THE PROPOSED A122 (LOWER THAMES CROSSING) DEVELOPMENT CONSENT ORDER

**Responses to ExQ1 submitted on behalf of
the Port of London Authority**

| Document Ref. | PLA 15 |

Comments on the Examining Authorities second written questions and requests for information (**ExQ2**) submitted by the Port of London Authority (**PLA**)

Extract from PLA Charts

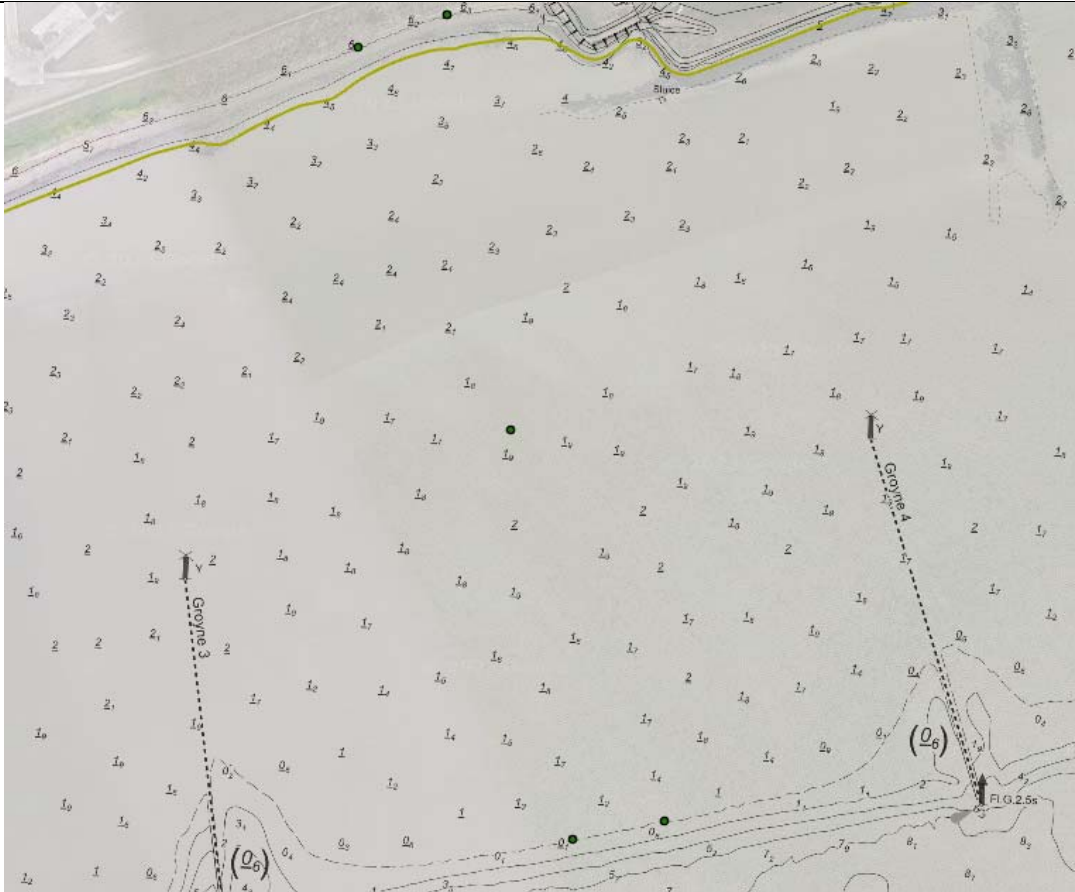
| | <p>adequate? If not, please provide details and suggested updated wording that you would consider to be adequate.</p> | <p>The DML states at paragraph 15(2)(a): <i>“works to construct the drainage pipeline and outfall referred to at paragraph 5(1)(a), including any piling, must <u>not</u> be undertaken when <u>the work area is either fully submerged, or partially covered by water</u>”</i> (emphasis added).</p> <p>There are three issues with this. Firstly, the DML is inconsistent with the register of environmental actions and commitments (REAC): the DML states that piling must not occur when the work area is partially covered by water, but the REAC allows for piling works to be completed at low water / when the area <u>is</u> partially covered by water. Secondly, the meaning of partially covered is not clear: does it refer to being covered for part of the day, for example, or that part of the area is covered? Lastly, the work area is not defined; it is not possible to tell whether an area is “partially covered” if one does not know what that area is.</p> <p>Unlike the DML, the REAC does envisage piling works being carried out at low water or when the working area is partially covered. See for example:</p> <ul style="list-style-type: none"> - REAC MB001 <i>“Works to construct the temporary drainage pipeline and outfall from the northern tunnel entrance compound, including any piling, must not be undertaken when the work area is either fully submerged or partially covered by water where this would result in the transmission through the water column of noise and vibration...”</i> <p>As set out in chapter 9 of the Environmental Statement (ES) (APP-147) the construction of the temporary outfall could result in a 300-400m sheet pile trench being constructed across the intertidal zone. The PLA has plotted on the chart extract below the co-ordinates provided for the discharge pipeline working area as set out in the table at 5(2)(a) of the DML (these are shown as dots on the chart). This shows that the working area and therefore piling for the temporary pipeline corresponds roughly with the drying line (0m above chart datum) as shown on the PLA’s charts.</p> |

PLA charts show levels relative to Chart Datum which is approximately Lowest Astronomical Tide, being the lowest tide predicted over a 19 year cycle. It is therefore necessary to convert the levels from Chart Datum to Ordnance Datum to understand whether the area would be covered by water at low tide. The information provided on the PLA charts to undertake this conversion is set out below:

At low water springs (occurring every fortnight) the most riverward point of the working area, i.e. the most southerly point to the bottom of the above extract of the PLA charts, would be covered by 0.63m on average of water. The PLA accepts that this is for the most riverward point of the discharge pipeline working area, but if the piling is proposed up to this most riverward point, it would not be possible to comply with the requirement in the DML of no piling when the area is partially covered by water as there is no point in the tidal cycle when the area would not be covered by water.

Other areas may be dry (i.e. not covered by water) at 'low water' but there will be a limited tidal window within which works can take place and by high water (approximately 6 hours after low water) the entire working area riverward of Mean High Water would be covered by water.

| | | <p>It is important that the apparent inconsistencies between the requirements in the DML and REAC are resolved to ensure that if working needs to occur when the work area is partially covered by water that this would not be a breach of the DML.</p> <p>The PLA also maintains that the controls described in the DML and REAC are insufficient given that the effects on underwater noise and vibration from tunnelling activities on the qualifying features of the Thames Estuary and Marshes SPA and Ramsar have not been fully assessed in the Habitats Regulation Assessment (HRA) [APP-487]. This relates to issues previously raised by the PLA relating to the effects of vibration and noise of underwater feeding waterfowl (see paragraph 22.8 of the PLA’s Written Representations [REP1-269]).</p> <p>It should also be clarified what ‘partially covered’ by water means: is it a depth of water, a certain amount of time after low water, part of the working area can be wet and part dry or something else?</p> <p>Finally, the work area should be a defined are. We expect that the work area will be smaller than that enclosed by the coordinates in the table at 5(2)(a) of the DML, given that the DCO seeks to leave a level of flexibility. One solution could be for the Applicant to notify the Marine Management Organisation and the PLA of the working area before those works commence.</p> |
